**Re: Safety Notice Pertaining to All Kuryakyn Multi-Purpose Driver & Passenger Backrests  
NHTSA Campaign no.: 13E-033**

Thank you for your support and understanding regarding Kuryakyn's Recall on our 1660/1661 Multi-Purpose Driver/Passenger Backrest. The following is updated information for you.

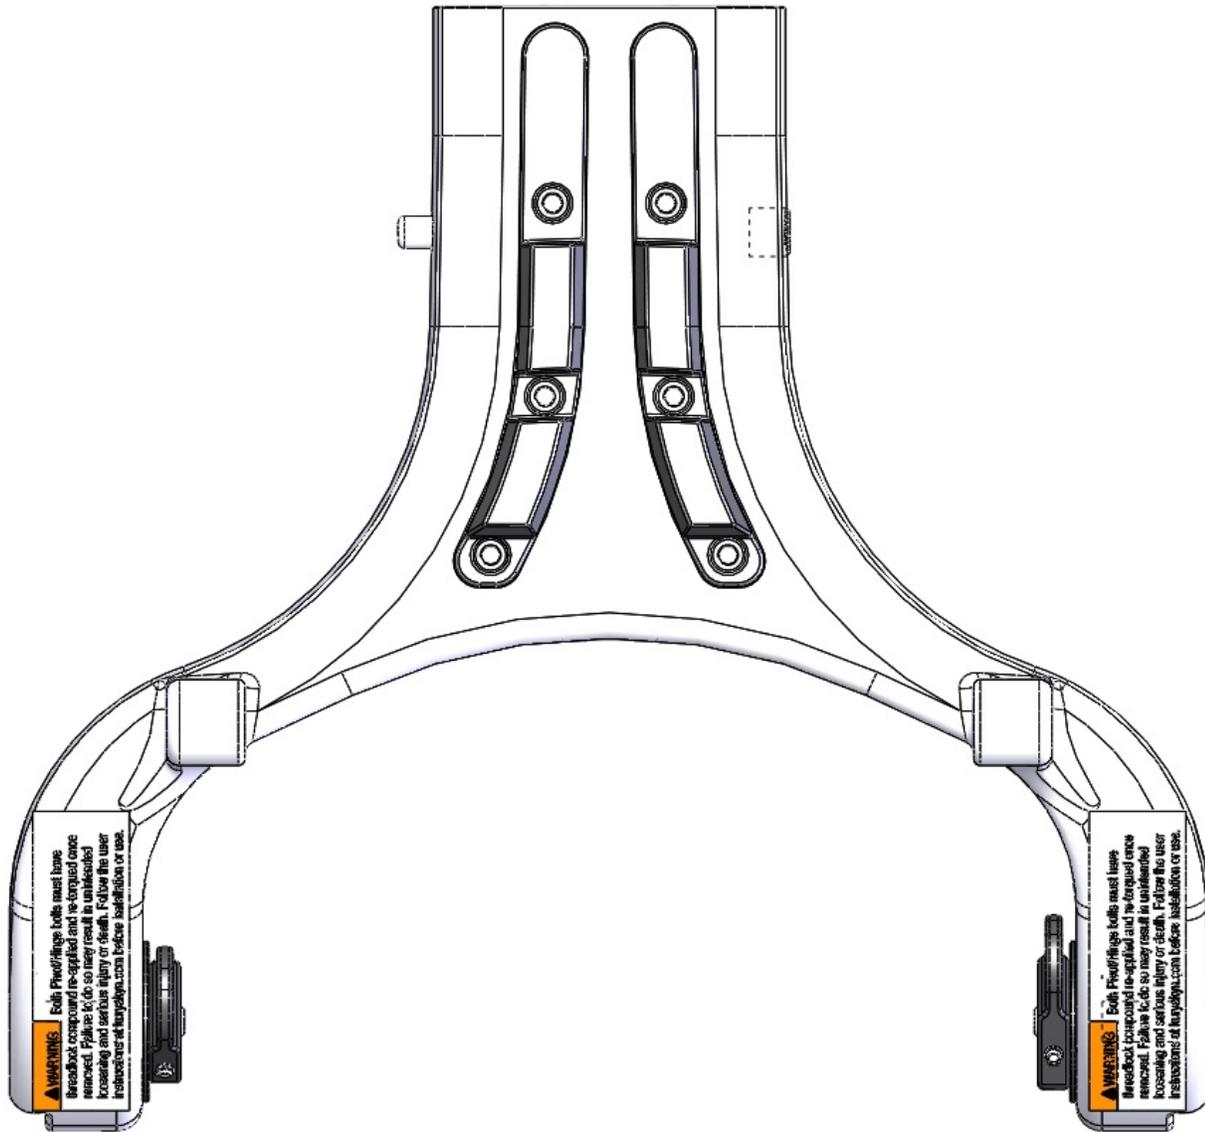
1. Remove the one existing hardware kit poly bag located in the bottom of the P/N 1660 or P/N 1661 box. The two chrome shoulder washers must be retained for reuse. **The two screws WITHOUT blue threadlock adhesive and the OLD instruction sheet (also inside the same poly bag) MUST be discarded along with the old poly bag. )**
2. Please carefully open the Recall Service Kit (re-sealable poly bag) and retrieve the warning label stickers and instruction sheet (2 pages) entitled "Recall Service Kit for P/N's 1660/1661 991660". Discard the "Recall Service Kit" instruction sheet, it is not needed to retrofit on-hand inventory. If you are retrofitting a P/N 1660 backrest, use the warning stickers with black text. If you are retrofitting a P/N 1661 backrest, use the warning stickers with white text. The stickers must be placed on both sides of the

backrest forging near the pivot attaching screw locations as shown in the photo below. The extra stickers that are not used should be discarded after the rework is completed.
